RE: Eagle and Radnor Roads

Gannett Fleming, Inc. has completed a review of the Preliminary Land Development Plan for the above referenced project for compliance with the Radnor Township Code. We have reviewed the plans based on a proposed zoning map revision that would convert this Parcel to R-2 from the current zoning designation of R-1 and PI. The map revision must be approved by the Board of Commissioners prior to this plan moving forward in the approval process. The applicant is proposing to construct 20 single family homes on individual lots. The Plan was reviewed for conformance with Subdivision and Land Development, Zoning and other applicable codes of the Township of Radnor.

Plans Prepared By: Site Engineering Concepts, LLC
Dated: 09/15/2020 and last revised 02/16/2021

RADNOR TOWNSHIP	DATE
SITE DESIGN & CONSTRUCTION STANDARDS	JUNE 1995
MANHOLE FRAME AND COVER	DRAWING NO.
	C-10

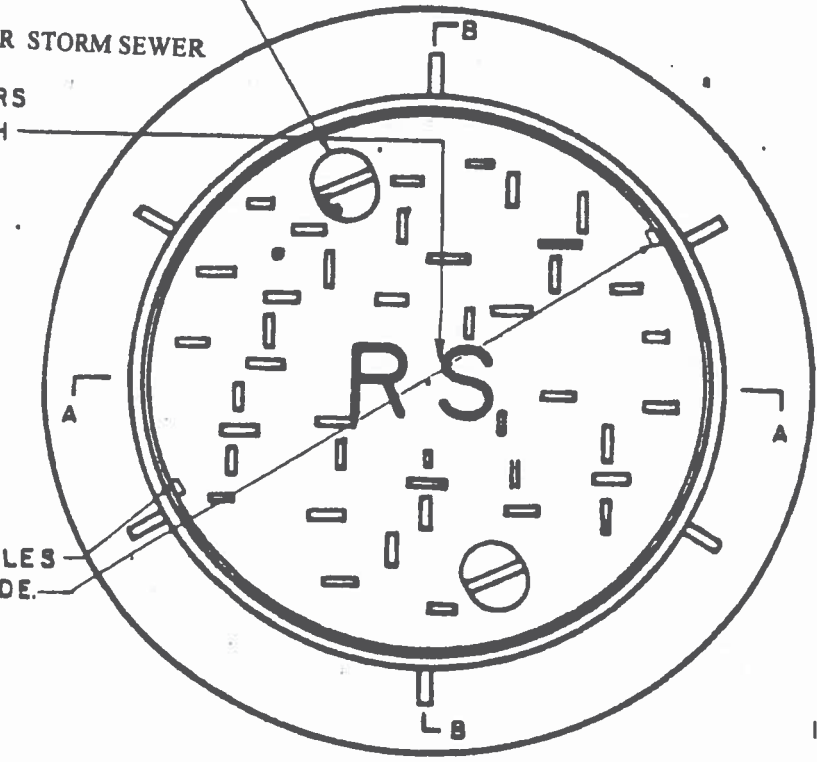
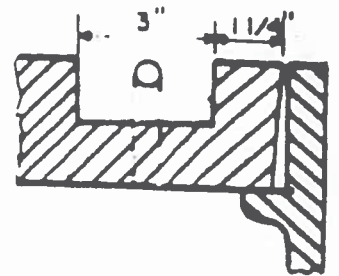
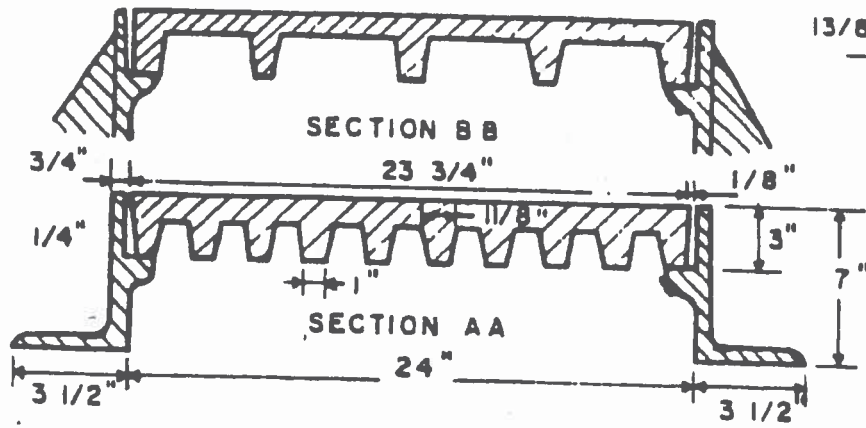
1. The sanitary sewer profile indicates two separate Lot 17 lateral connections. This must be revised.
2. Please use the attached detail for standard Manhole Frames and Covers. The Detail provided on the plans are for the watertight covers in non-paved areas only.
